STATE OF MAINE
DEPARTMENT OF TRANSPORTATION
☐ Approved
☐ Returned for Corrections
AUG 2[illegible] 1997
☒ Approved as noted
☐ Rejected

PROJ. NO. : BH-043-1(34)
ITEM NO. : 520.22

PROJECT: JOSHUA CHAMBERLAIN BRIDGE OVER THE PENOBSCOT RIVER, BANGOR-BREWER, ME

EXPANSION JOINT DETAIL @ PIER 1

SECT. C-C

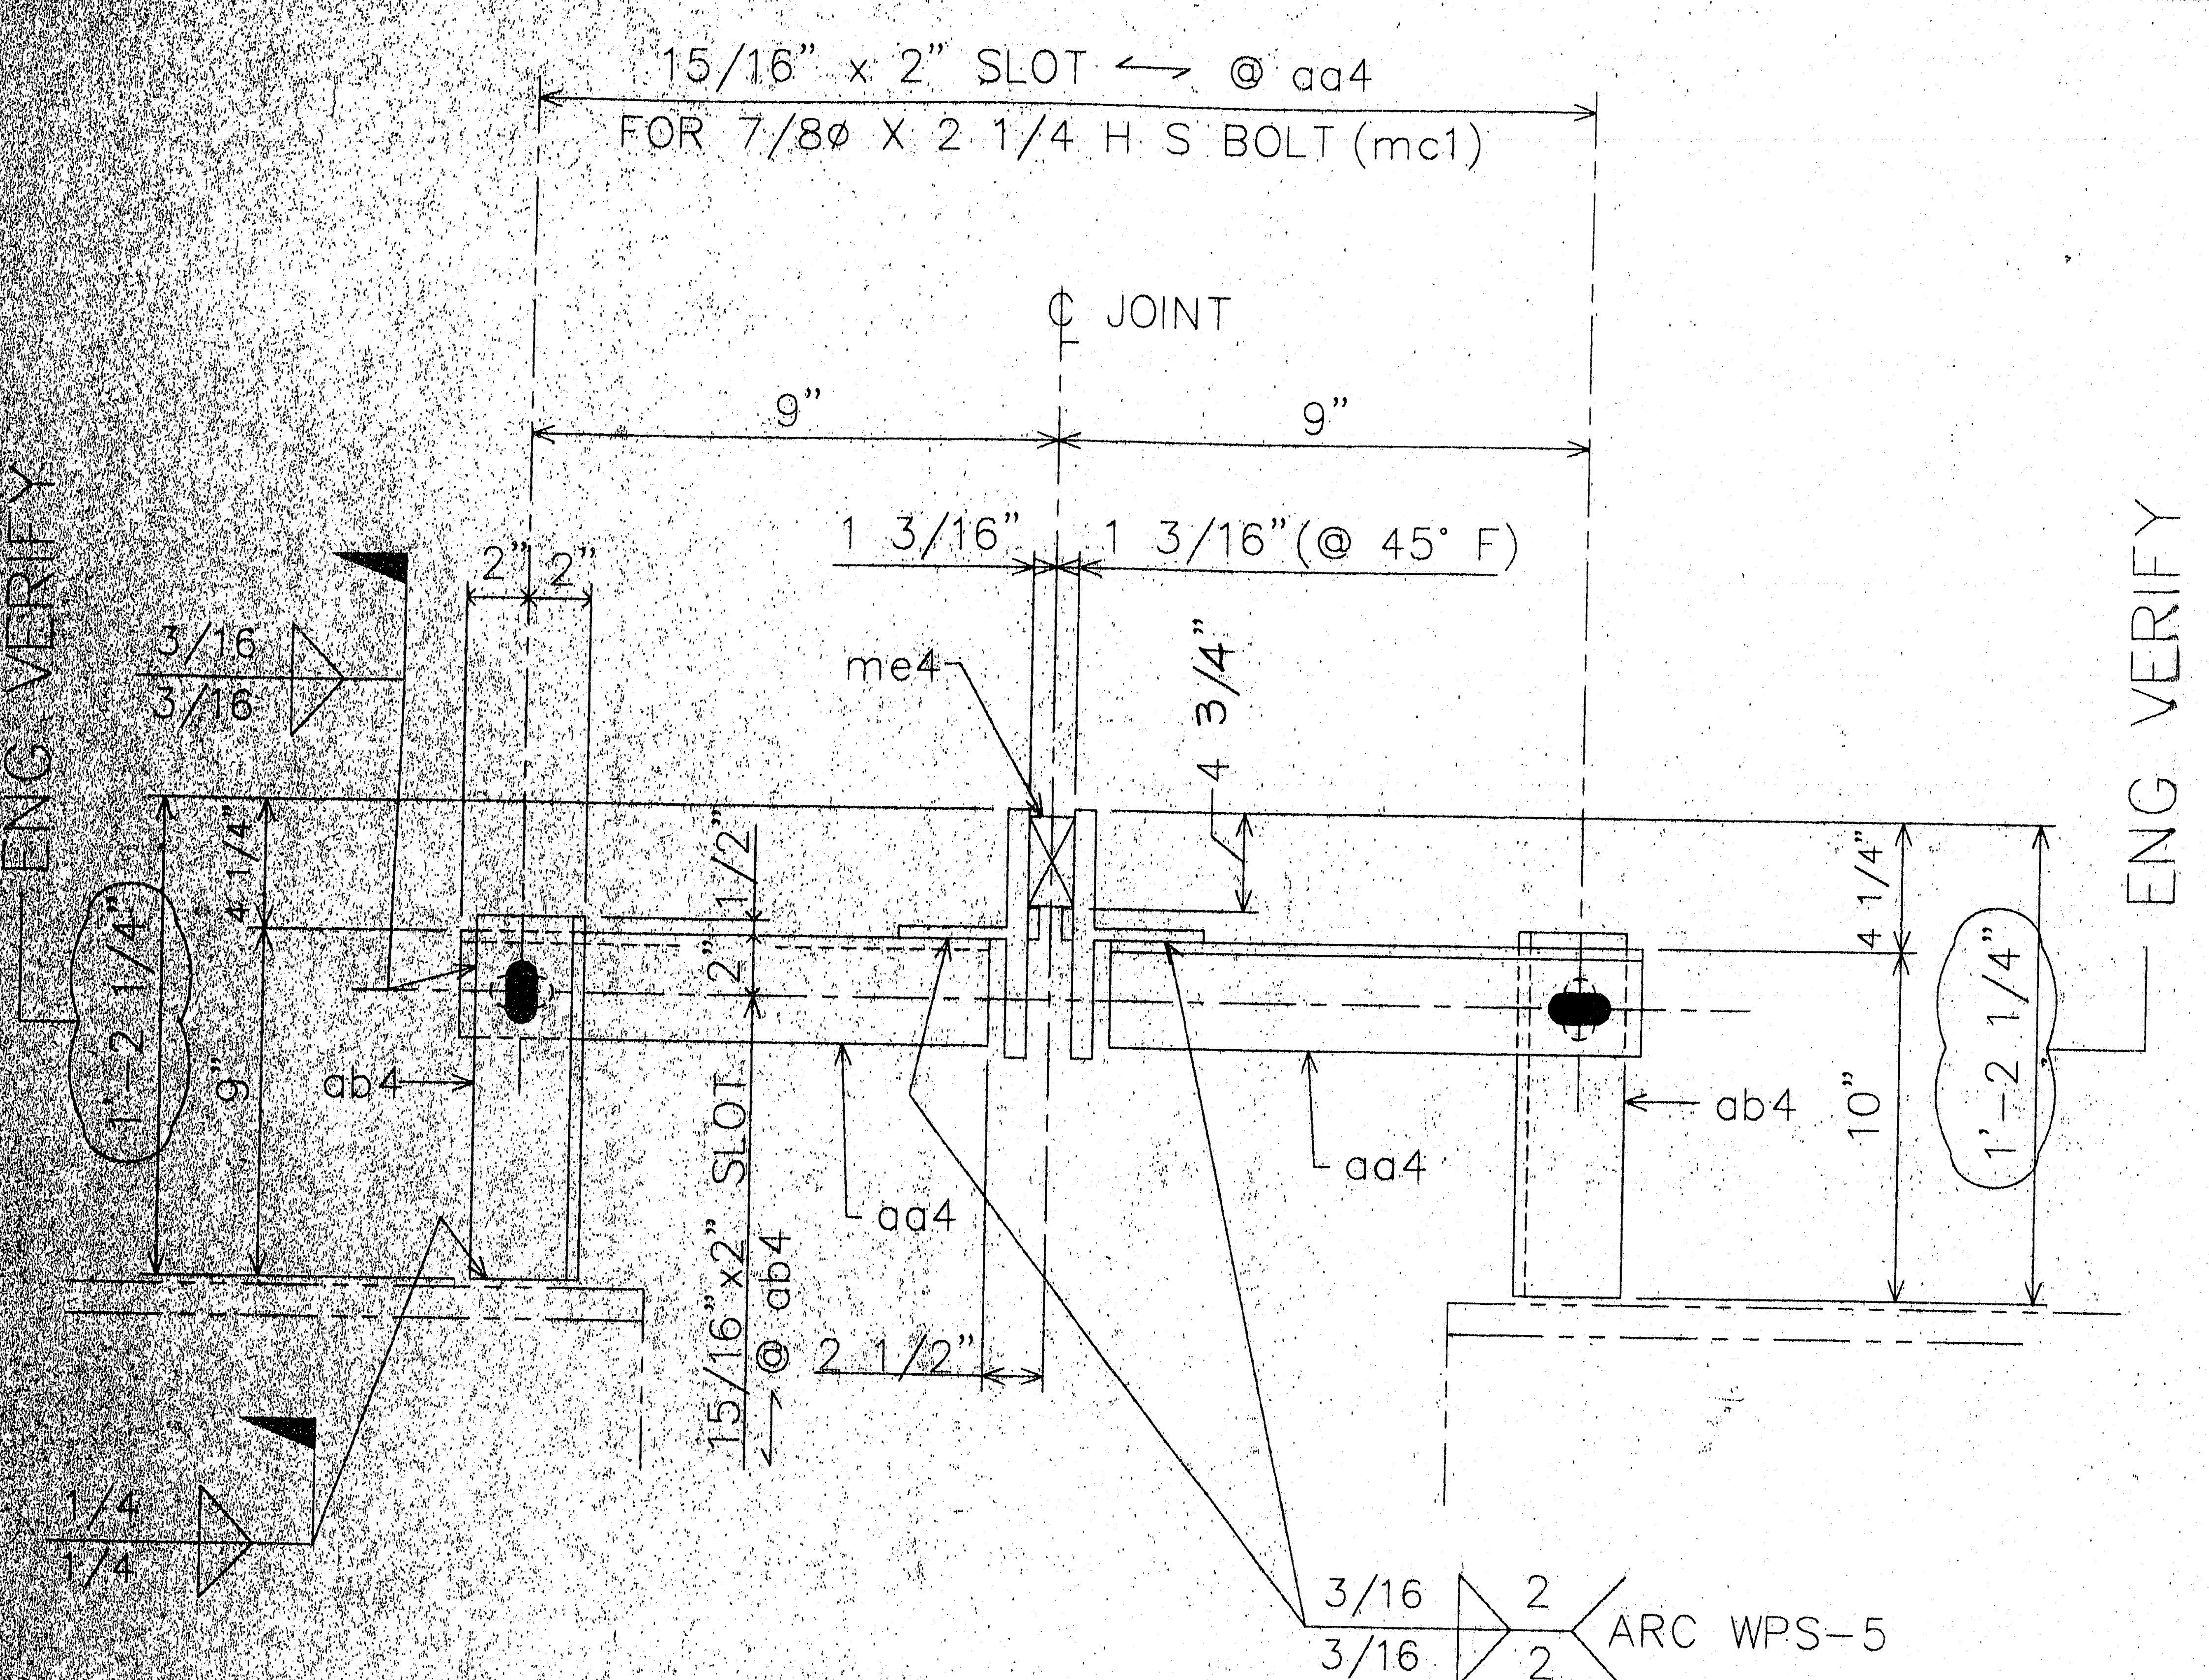
In field. Contractor

PROJECT: JOSHUA CHAMBERLAIN BRIDGE OVER THE PENOBSCOT RIVER, BANGOR-BREWER, ME
SCALE: ~
DATE: 7/97
APPROVED BY:
DRAWN BY: BB
CHKD. BY:
SIDEWALK DAM DETAIL @ PIER 11
REED & REED
JOB NO. 97-49
DWG. NO. 22

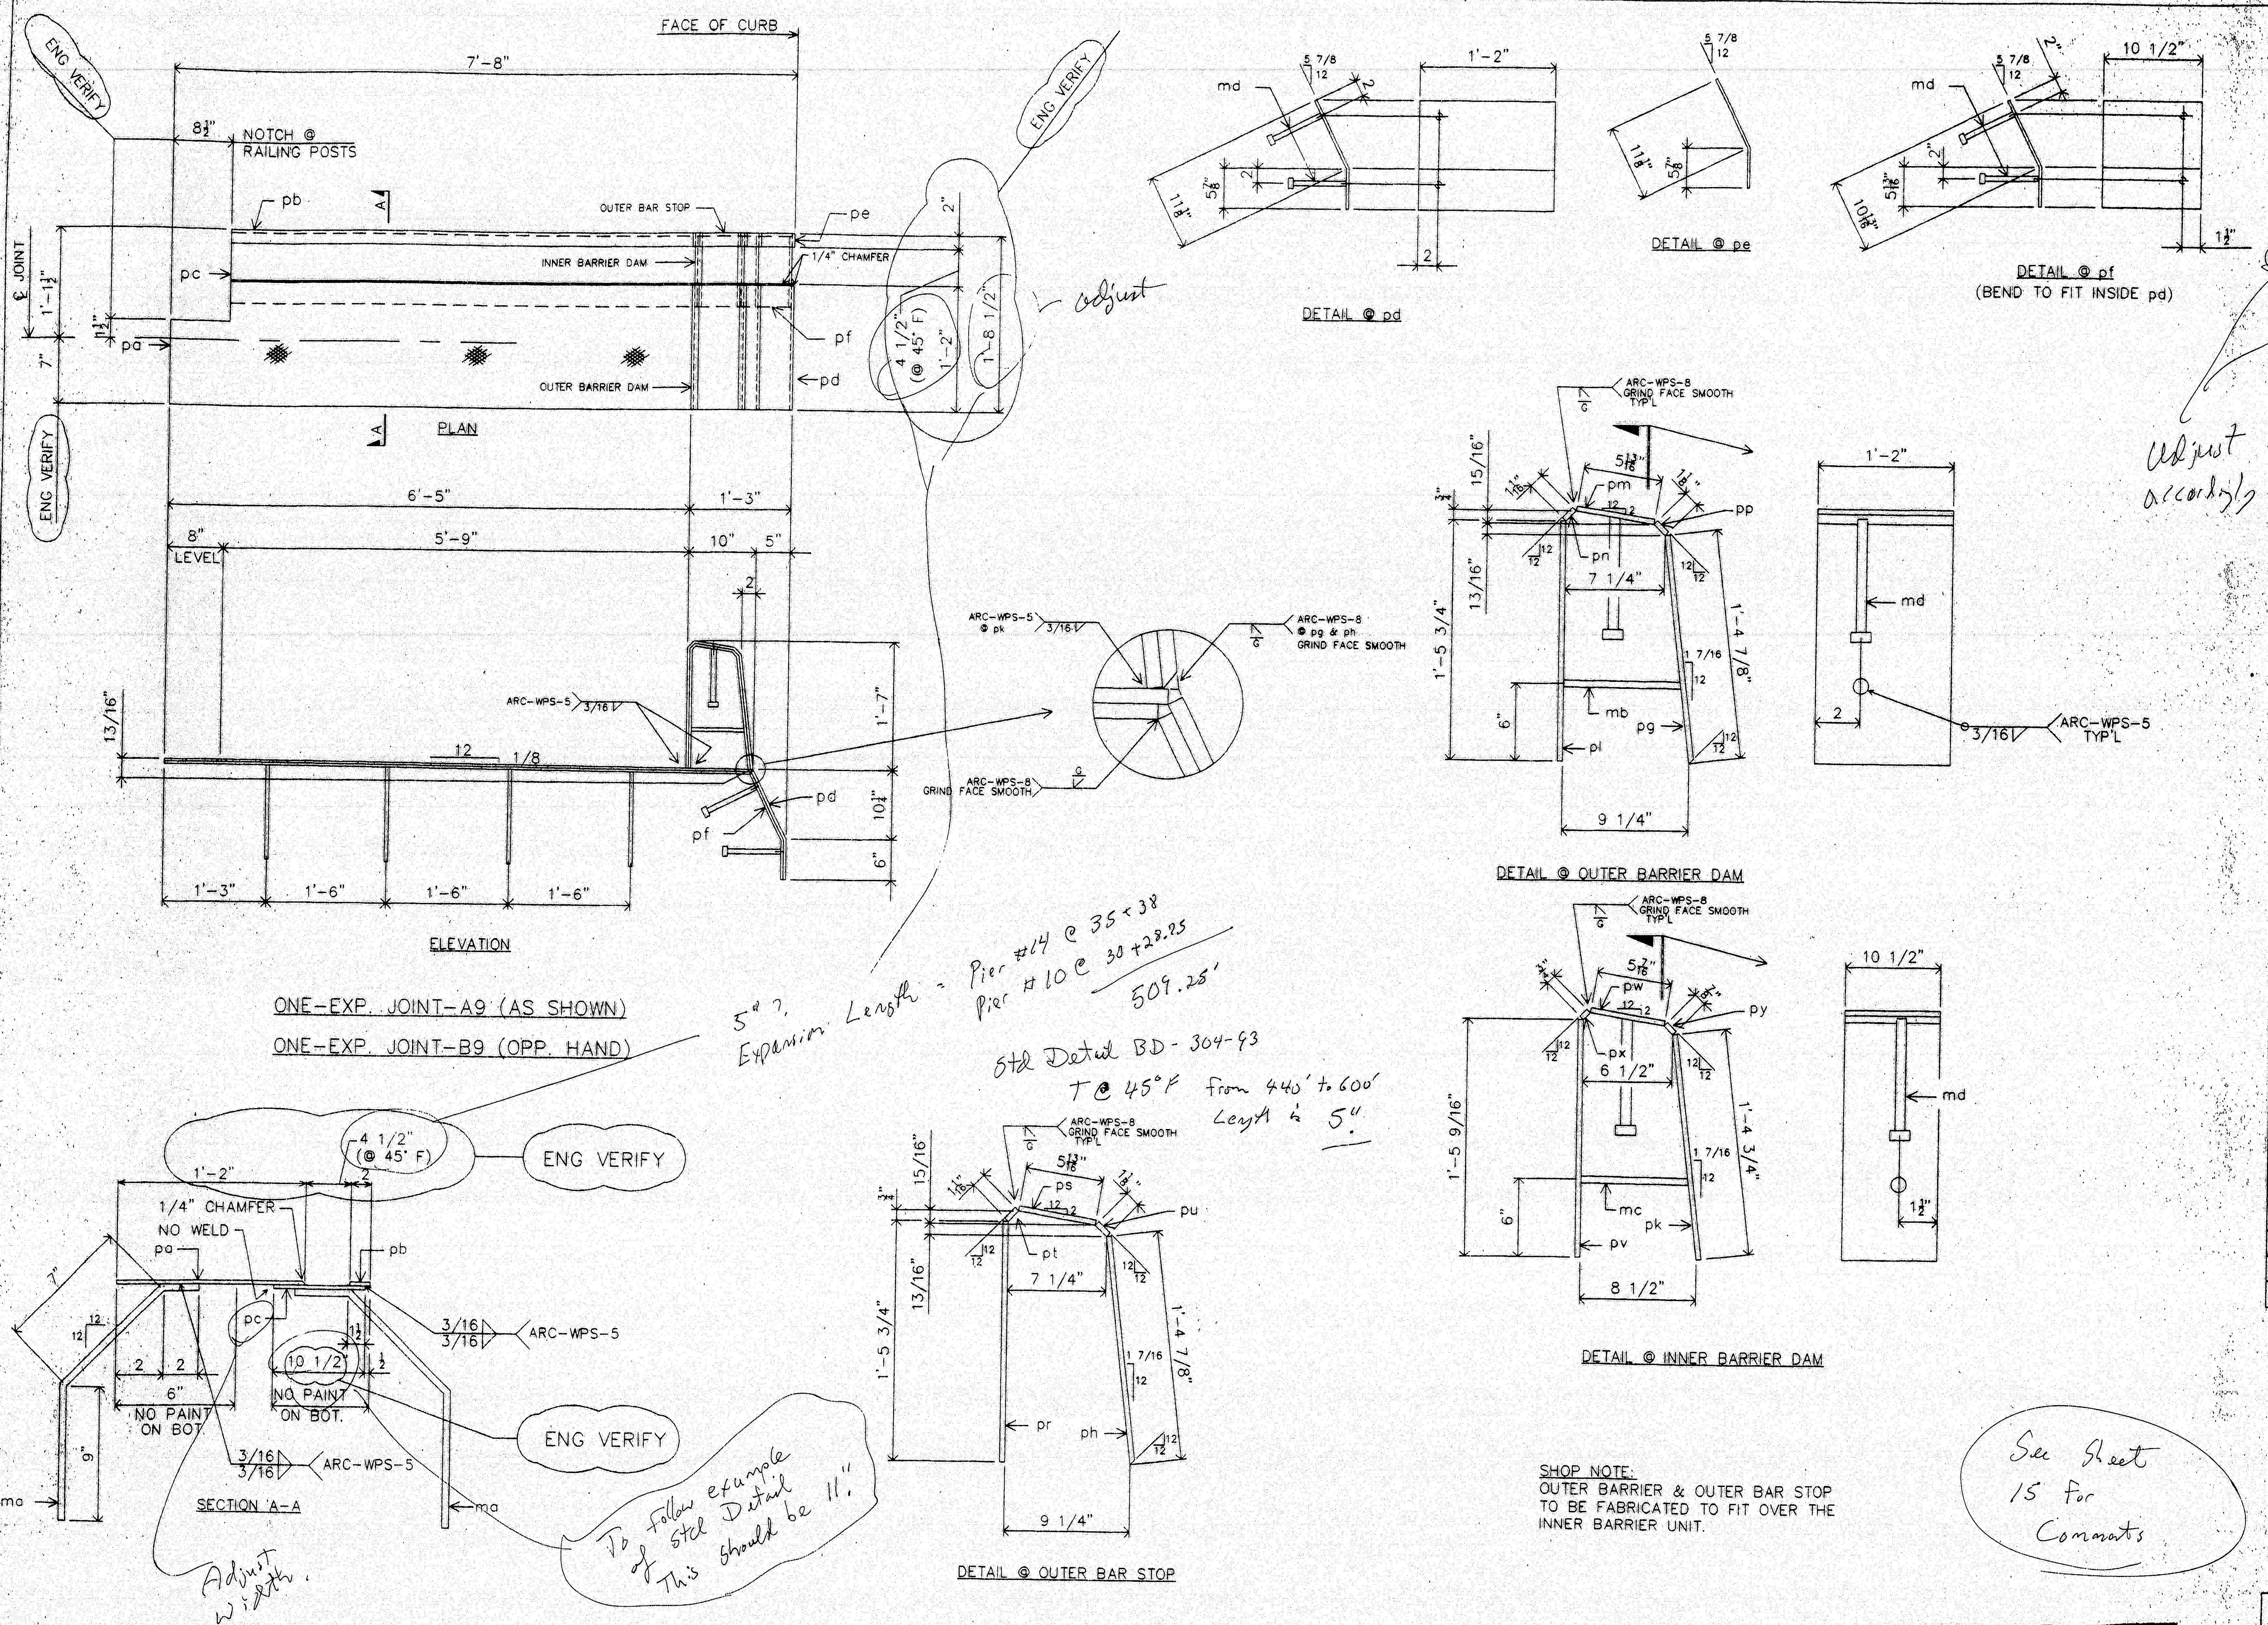
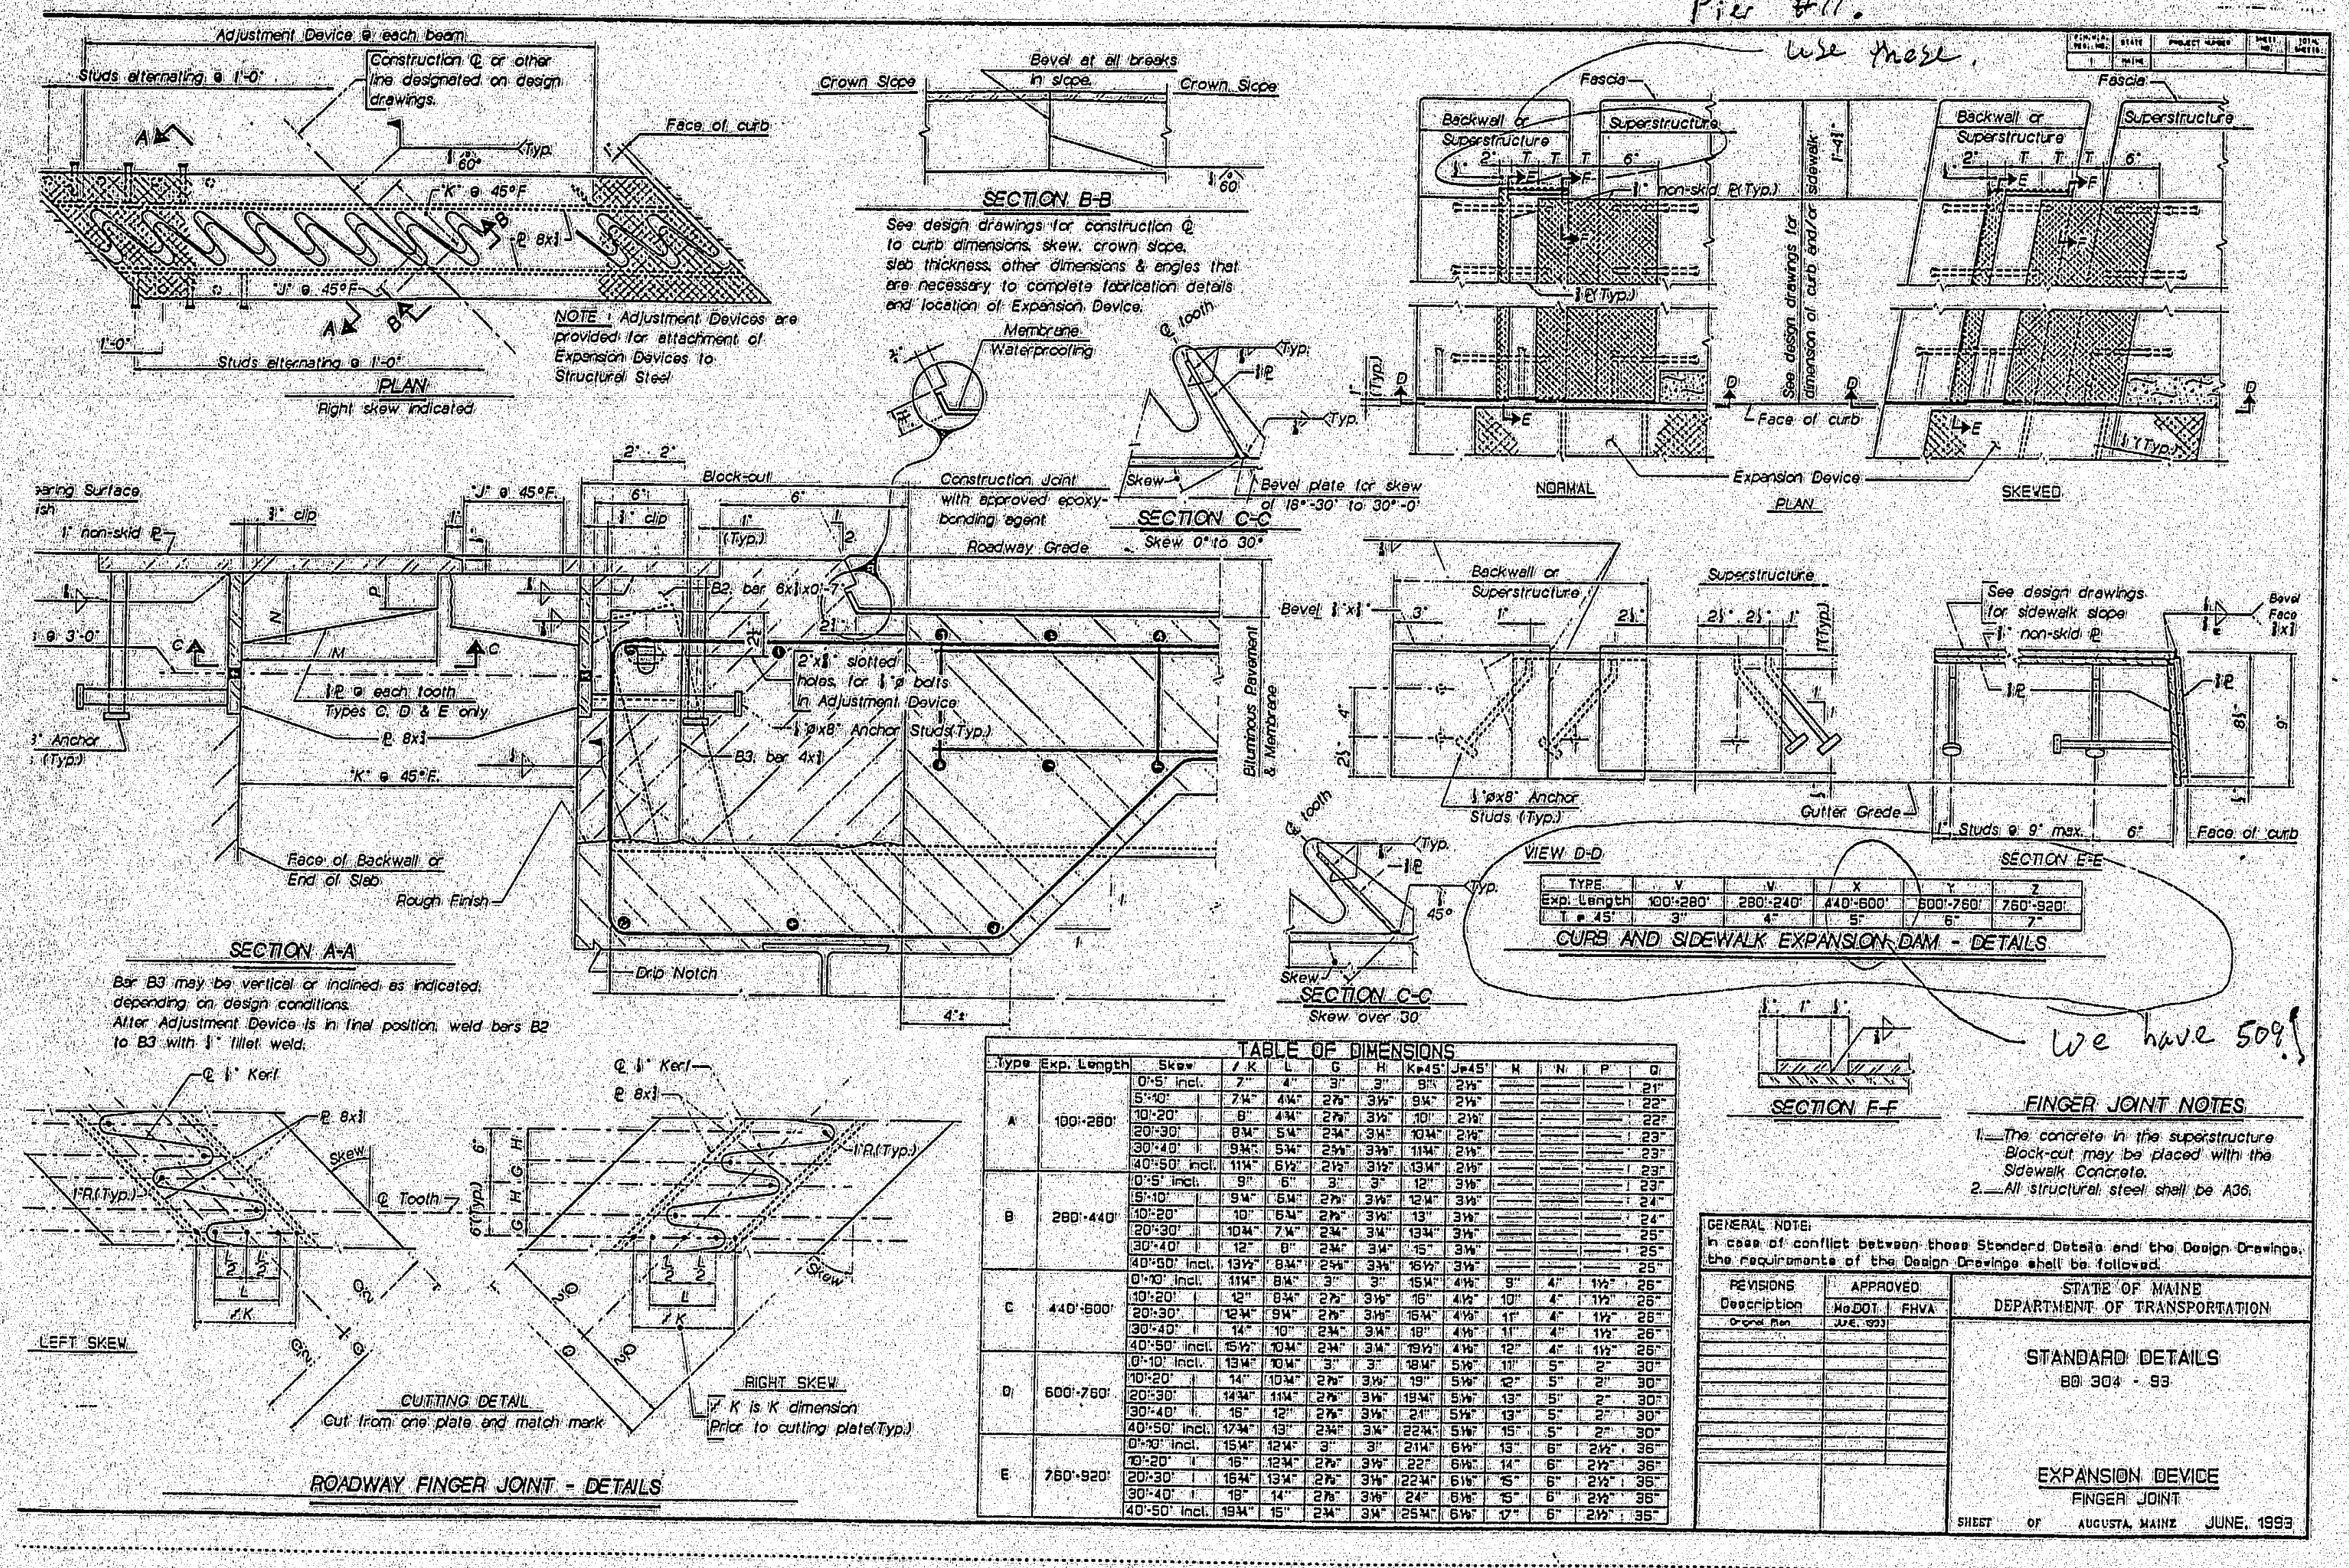
Adjust

5" ?
Expansion Length = Pier #14 @ 35+38
Pier #10 @ 30+28.75
509.25'

Std Detail BD-304-93
T @ 45°F from 440' to 600'
Length is 5"

Adjust width.

To follow example of std Detail This should be 11".

Adjust accordingly

We have 509!
